Dr. Robert Bagoff- Chair
West Orange Planning Board
66 Main Street
West Orange, NJ 07052

RE: PB-24-01 West Essex Highlands, Inc
Block: 179 Lot: 32 Zone: IH-1 Warner Road
West Orange Township, Essex County, New Jersey

At the request of attorney Bruce Afran, counsel for objectors and We Care NJ Corp., Princeton Hydro has performed an independent technical review of the aforementioned development located in West Orange Township, NJ. The project is also the subject of a Planning Board Approval from the West Orange Planning Board.

Figure 2: Example of Soil Profiles that use the Munsell Method to document SHWT and the Soil Profiles for this project

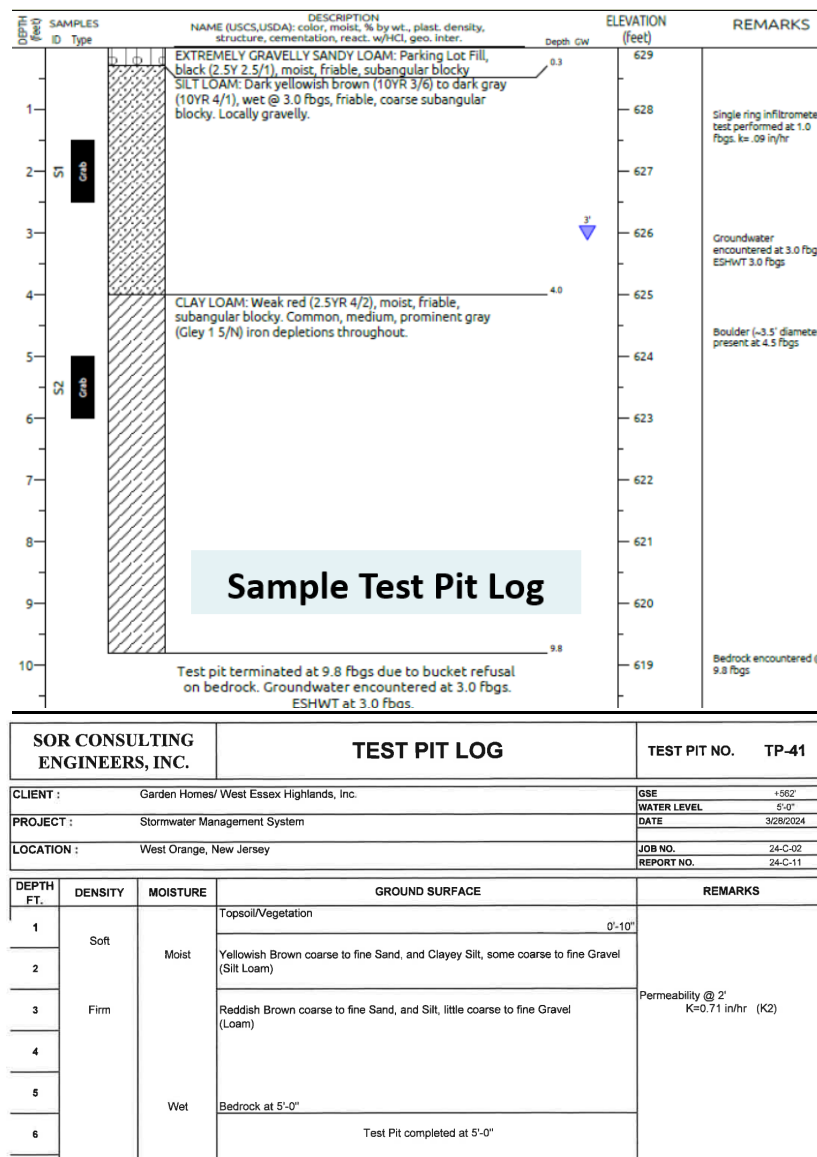
While reviewing the multiple subsurface investigation reports for this project, the soil profiles never make any mention of mottling. That is very unusual, as stated above the BMP Manual states that mottling should be used to established using mottling with the observed water level. Importantly, soil logs must also be specific in their identification of various color throughout the profile, as is consistent with the *Field Indicators of Hydric Soils in the United States* referenced by the NJDEP BMP Manual. Color identification is key in correctly identifying mottling by recording both the number of different colors observed, as well as the value and chroma of the observed colors. Figure 2 provides a comparison of a sample soil profile which uses the Munsell method per the *Field Indicators of Hydric Soils* (top) and the soil profiles for this project (bottom).

It appears that the SHWT was only established using the elevation of the water found in the test pit or boring and no effort was made to document mottling. As noted in the NJDEP BMP Manual, there are instances where mottling can be absent from a soil profile, but it is highly unusual that mottling was not found in any of the soil test pits or borings provided by the applicant. Mottling is a natural and common process, thus it is fair to assume mottling should have been observed in some of the soil profiles. The concern is that the groundwater level found in a test pit can fluctuate on a daily basis based on the recent weather. Using the mottling to determine the SHWT is recommended because it estimates the highest (most conservative) elevation that does not vary with time. If one only uses the observed groundwater elevation, it is safe to assume that the SHWT elevation is probably underestimated. It is recommended that the professionals who documented these test pits should provide the Planning Board with testimony to explain why mottling was never documented and discuss the how their reports could be underestimating the elevation of SHWT.

Figure 3: Cross Section of PP6, Proximity of TP-4 to PP6 and TP-4 Soil Profile

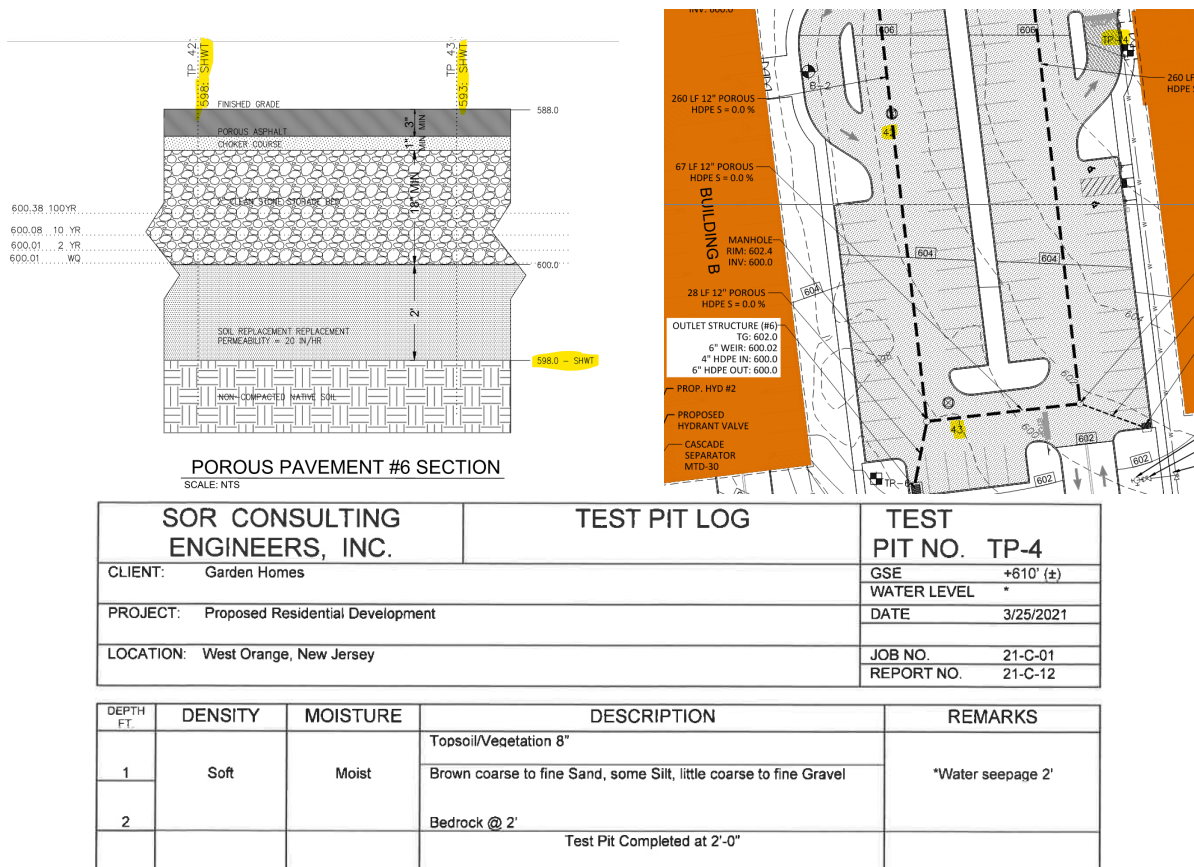
BMP 6 shows a SHWT of 598 ft using the 2024 soil testing data but 2021 shows a different story. TP 4 shows seepage at 608 ft, which is 10 feet higher than what the plans show. Based on this finding, the porous pavement design not compliant. The SHWT intersects the storage volume of the basin as shown in Figure 3.

Figure 4: Cross Section of PP4 from Construction Plans, Proximity of TP-10 to PP4, TP-10 Soil Profile

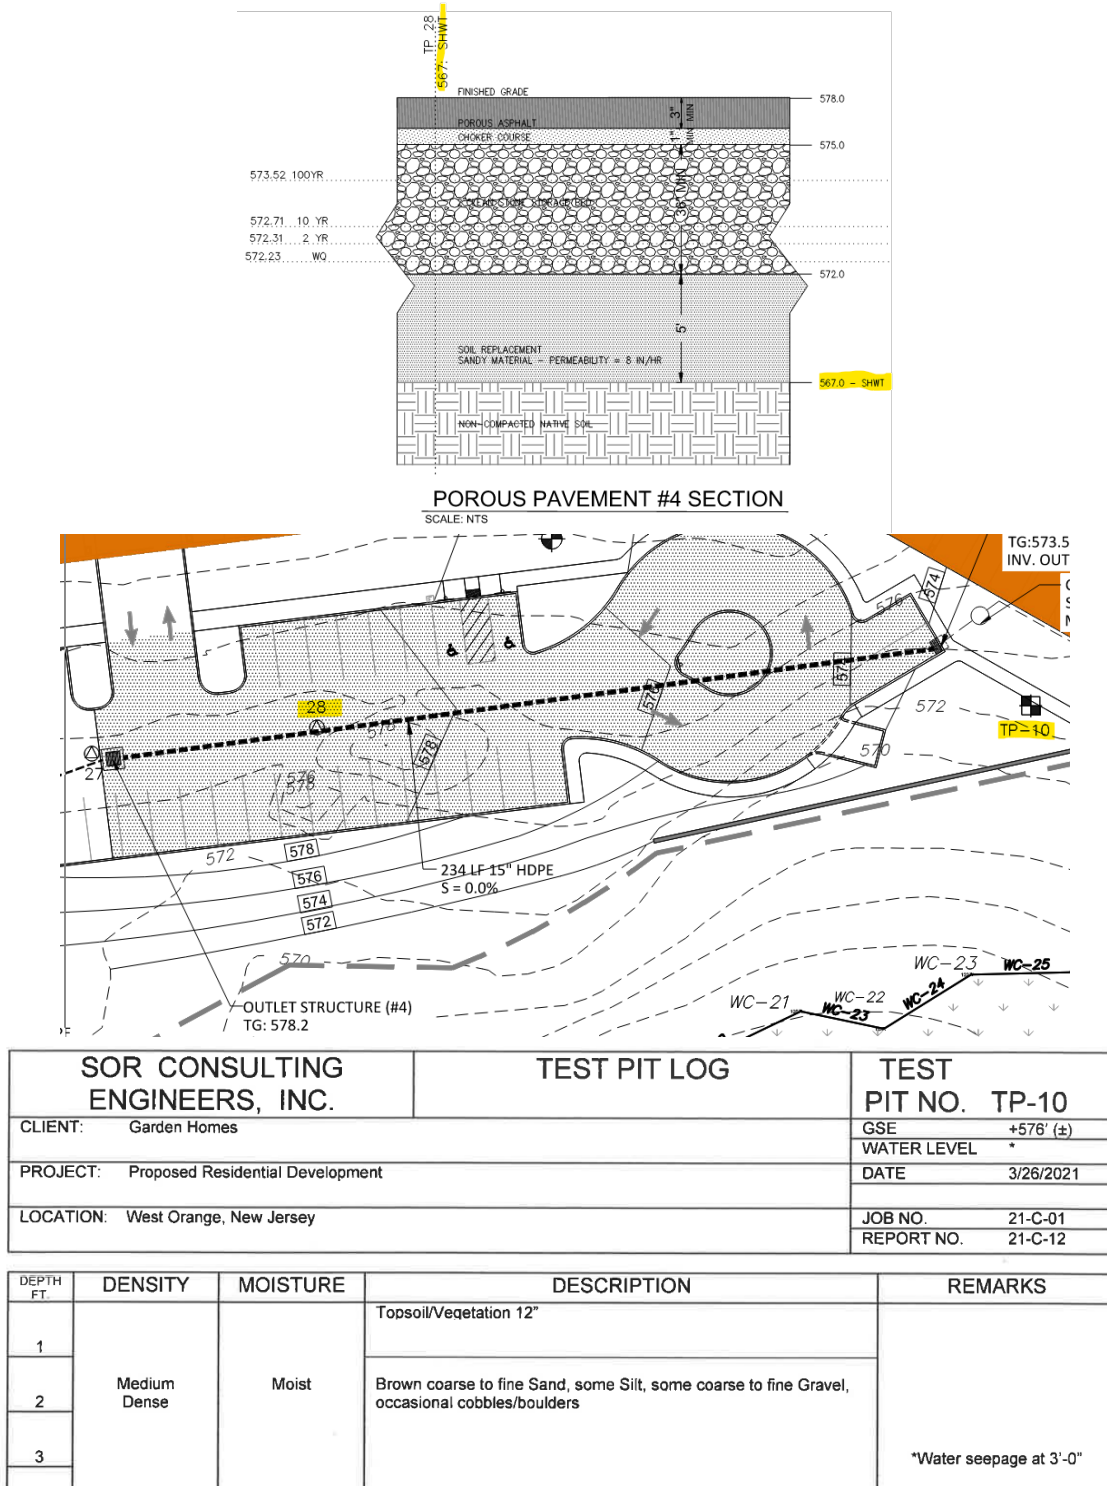
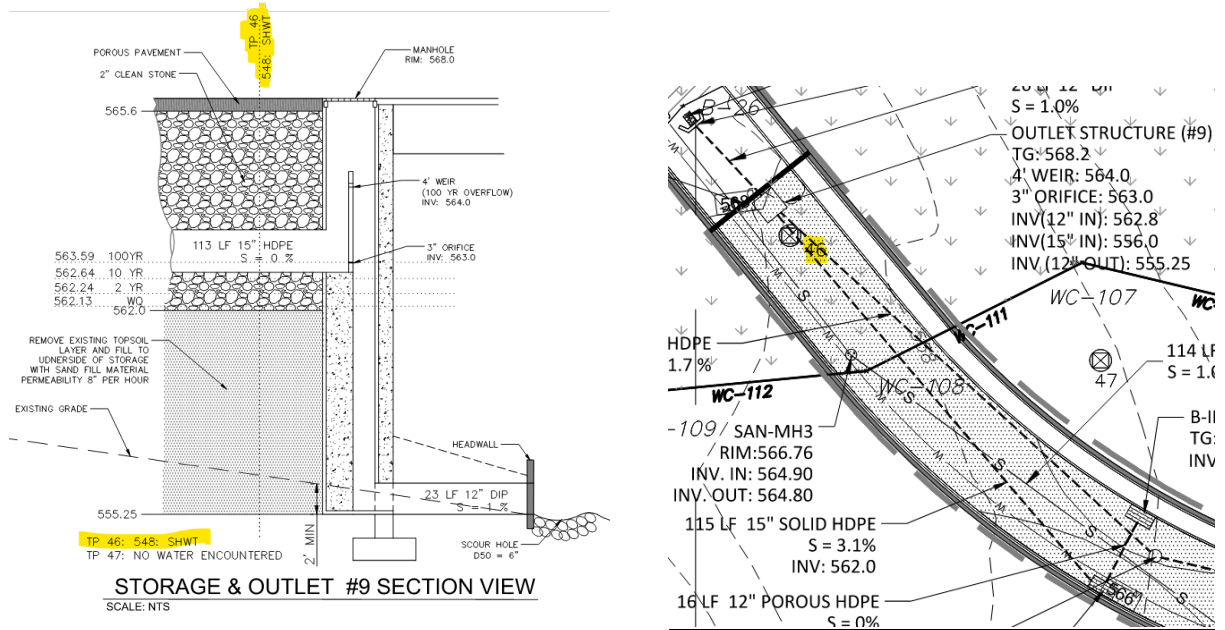
Likewise, BMP 4 records the SHWT at 567 ft (Figure 4) on the plans but that is only using data from the soil tests taken in 2024 (TP 28). In 2021, soil tests were also taken and TP 10 (Figure 4) is very close to BMP 4. TP 10 shows a SHWT of 573 ft, 6 feet higher than TP 28 which would have the SHWT intersecting the storage bed of the BMP. Please note that there is an error on the TP-10 soil profile. On the right-hand side of the document, there is an entry for the water level found; it is left blank. Elsewhere on the document it states that seepage was found at 3

feet below grade which is an elevation of 573 ft (576 ft - 3 fbg). Seepage is water leaking through the side walls of the soil profile, the seepage is an indicator of the SHWT and it should have been marked that way.

Figure 6: Cross Section of BMP 3.

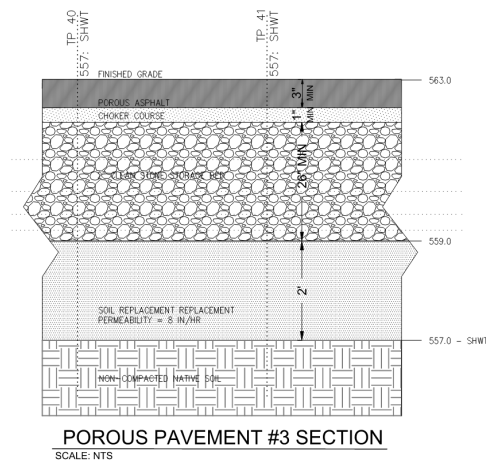
During the water quality storm, BMP 3 infiltrates 880 cf of runoff. The area of the infiltration basin is 5,558 sf. 880 cf of water is equivalent to about 2 inches of water over the area of the basin. That means that two vertical inches of water will be held above the SHWT and slowly infiltrate. Assuming a void space factor of 0.4 for the sand layer, the 2 inches of vertical water realistically equates to about 5 inches, meaning that there is 5 inches of water in the sand layer between the SHWT and the bottom of the storage for PP3. The system works under this scenario because the soil replacement area is 2 feet deep. Under the 100 year storm, the model assumes that 10,971 cf of water will infiltrate through the system (page 529 of 946 in Drainage Report). That is because the model is assuming the runoff is infiltrating through the soil replacement area at a constant rate of 10 inches per hour. The reality is the at the surface of the basin, the runoff will infiltrate at that rate but once it reaches the SHWT, it will infiltrate at the much slower rate of 0.25 inches/hour (assuming a factor of safety of 2, based on the soil testing results) and will cause water to back up into the sand layer. There needs to be thick enough layer of sand to prevent that runoff from backing up into the storage area of the BMP 3. 10,971 cf of water over the area of the basin is equal to 1.97 ft of water. As noted above when you apply the 1.97 feet of water to the void space ratio of sand (0.4), the height of the sand and the water is 4.93 feet (59.16 inches) from the SHWT. BMP 3 only provides 2 feet of sand storage and an additional 26 inches of stone storage (see Figure 6). The system will become overwhelmed during a 100 year storm and the peak flow rates will not be reduced. Instead of infiltrating, a large portion of the 10,971 cf that the model says will infiltrate will discharge through the stormwater system. The design will fail and potentially create higher peak flow runoff rates than currently exist. Furthermore, this issue will compound elsewhere on the site. When BMP 3 is overwhelmed, the excess flow will be captured by inlets further downstream, potentially exceeding their capacity, thus resulting in uncontrolled discharge from the site and risking flooding downstream. If the excess runoff is captured by the inlets, the runoff would then enter either BMP 1 or 2, and similarly could overwhelm those systems and increase the peak flow rates from those BMPs as well.

Figure 7: Proposed Grading Plan with Blue Arrows showing the existing drainage path and the red arrows showing the proposed drainage paths and how the runoff is being diverted from the wetlands.

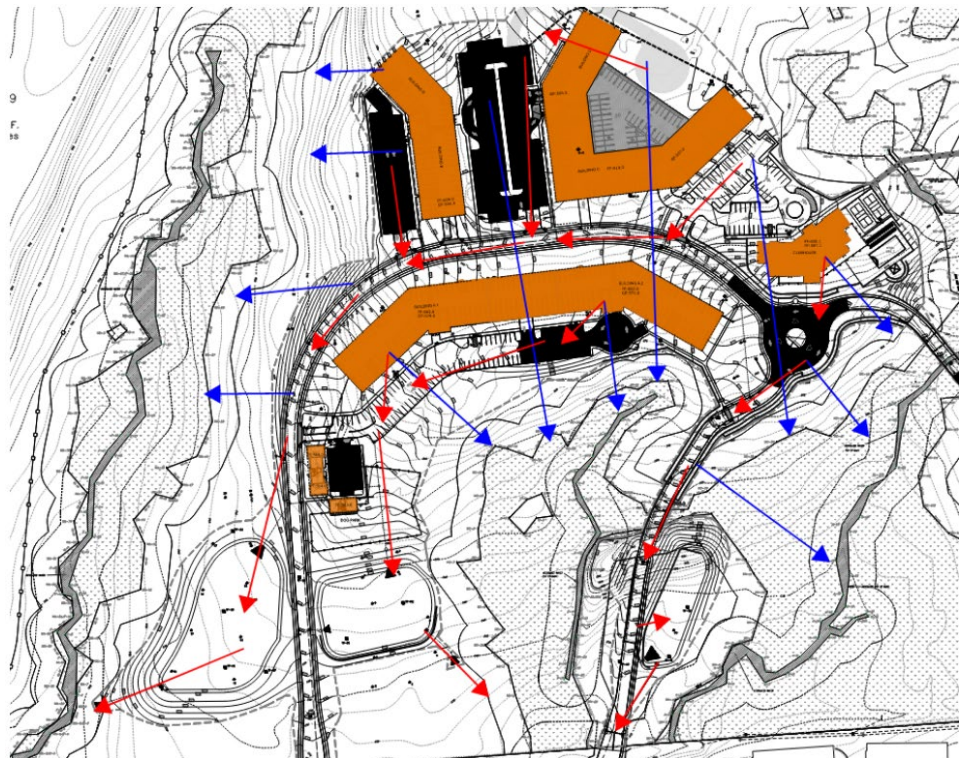
In the existing conditions, the stormwater runoff generated from the existing topography travels over the surface and reaches the upgradient wetlands, providing valuable water to the wetland ecosystem. In the proposed condition, the discharge locations for each of the drainage areas are at the bottom of the project area, as illustrated in Figure 7. The blue arrows indicate the existing flow paths and the red arrows indicate proposed. The proposed stormwater system intends to route the stormwater runoff through a pipe network to down-gradient basins where all of the surface runoff will discharge much further downstream. The wetlands uphill of the discharge locations will therefore collect less stormwater runoff due to their reduced contributory drainage areas.

Princeton Hydro included two attachments that show the existing drainage areas for eastern and western wetlands. The western wetlands have a drainage area of approximately 32 acres. The proposed improvements to this area will reduce the drainage area by 9 acres, or 28% of the total existing drainage area. The eastern wetlands have a drainage area of 48.4 acres. The proposed improvements to this area will reduce the drainage area by 16 acres, or 33% of the total existing drainage area.

Figure 8: Existing Conditions Drainage Path for POA-2, demonstrating how the analysis stops approximately 700 feet short of the POA location

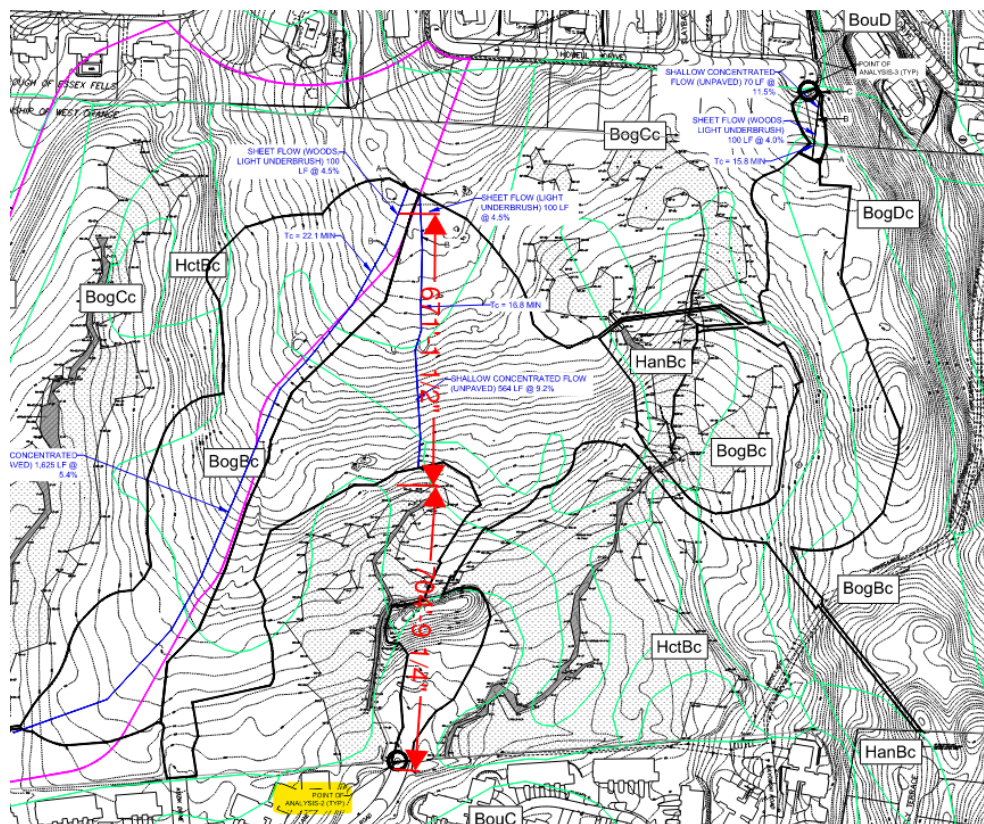
The flow path shown on the drainage area map for POA 2 is only 664 feet long and that matches what is shown on the model. The TC is meant to measure the time it takes for the water to travel the entire flow path. The actual flow path for POA 2 is greater than 664 ft. The discharge location is approximately 700 feet away from the end of where the analysis ends (as the crow flies, see Figure 8). This analysis is incorrect and incomplete because it does not capture the entire length of the flow path.

This is similar to using the older TC calculation, it artificially shortens TC so it lessens the existing peak flow rates and potentially risks the proposed improvements increasing the flow rate leaving the site instead of decreasing.

To understand the impact that the TC errors have on the design, Princeton Hydro calculated the TC for POA 2 using the correct method and entire flow path. The report has a total TC of 16.8 minutes. The Princeton Hydro calculations show a TC of 60.8 minutes, approximately 3.5 times longer. The resulting 2-year peak flow using the TC as calculated by PH is 7.52 cfs, whereas the applicant's model states 14.76 cfs (page 22) and the report states 17.53 cfs (page 22). In addition to severely overestimating the existing peak outflows, the values as listed in the report do not match the flow rates in the model, which must be corrected. Note that Princeton Hydro evaluated the applicant's calculations against the model results not what is in the body report. Based on the corrected time of concentration calculations, the maximum allowable peak flow rate for the 2 year storm is 3.76 cfs. Currently, the design's peak flow rate is 7.24 cfs, almost twice what should be permitted.

Figure 9: These are images of DA-1 and DA-2 from the Stormwater Report for the existing condition (left) and proposed condition (right) to demonstrate that the DA for POA 2 should be modeled as two separate DAs because there are two distinct points of discharge.

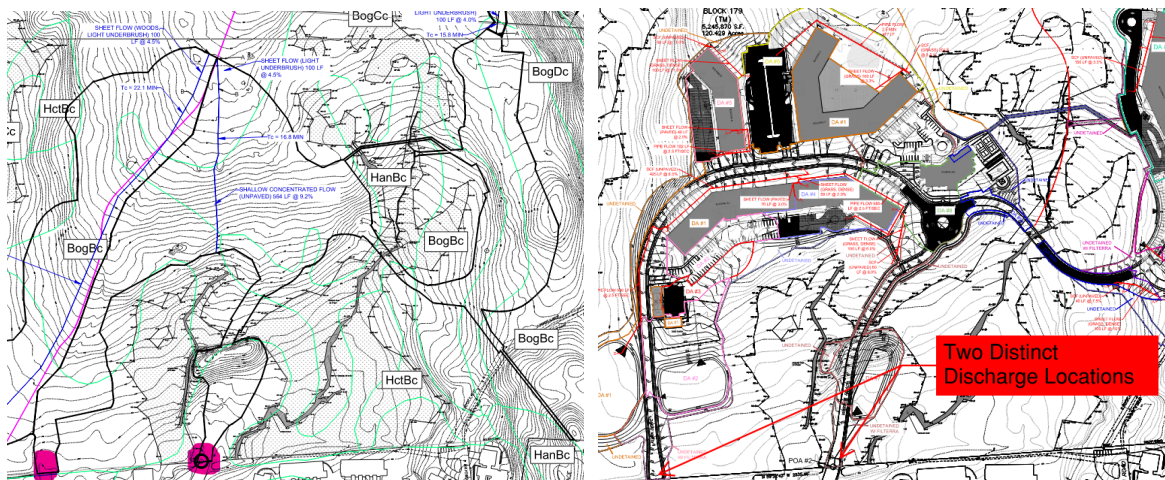
The analysis of the existing drainage area for POA 2 has yet another flaw. The topography within the area delineated for POA 2 has two clear discharge locations in the proposed condition, but it only assumes discharge location at Kuzik Road (see Figure 9). The design maintains both discharge locations, but the modeling assumes they are combined. The flows do eventually combine approximately 600 ft downstream into the adjacent neighborhood, not at the boundary of the site as currently assumed by the model. The drainage area analysis should be redone and the drainage area should be split into two separate drainage areas with two separate points of analysis to ensure the peak flow rate at both locations are compliant. It is difficult to predict how this will impact the site design, but it could be substantial. This re-evaluation is necessary to ensure that the peak flow rate of runoff from the site is compliant with the state and local regulations and to prevent downstream flooding.

Figure 10: Profile of BMP 9 showing a sanitary line traveling through it.

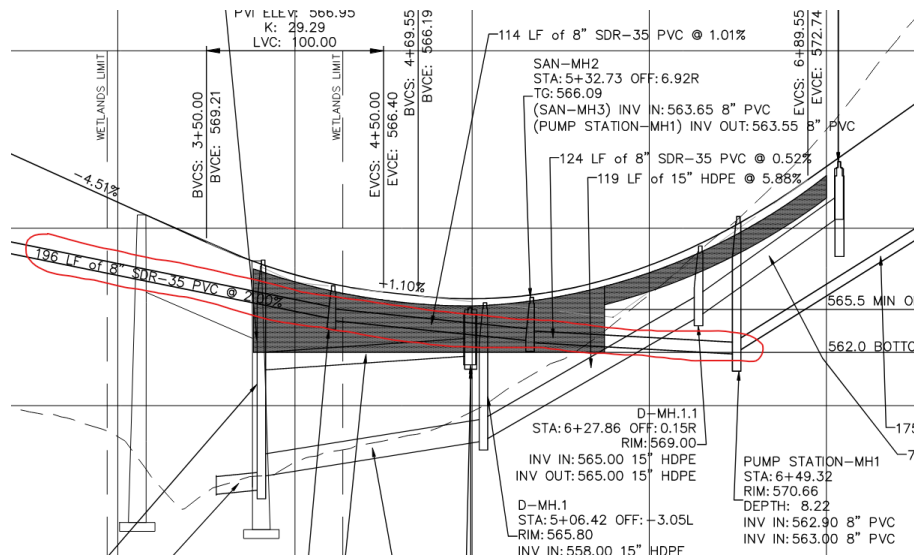
The design has a sanitary pipe traveling through porous pavement system (Figure 11). While Princeton Hydro could not find a specific rule against a sanitary line traveling through a subsurface basin, there are rules dictating adequate separation between stormwater piping and sanitary piping. Stormwater pipes and sanitary pipes should maintain a minimum horizontal distance of 10 ft and a minimum vertical distance of 1 ft, and the sanitary line should be below the stormwater pipe. The purpose of the separation is to prevent leaking sanitary pipes from entering the stormwater system and potentially causing an illicit discharge of raw wastewater. The design should be modified to relocate the sanitary pipe out of the subsurface system. This may require the project to have additional Flood Hazard and/or Wetlands Permitting depending on how the layout is impacted by this modification.
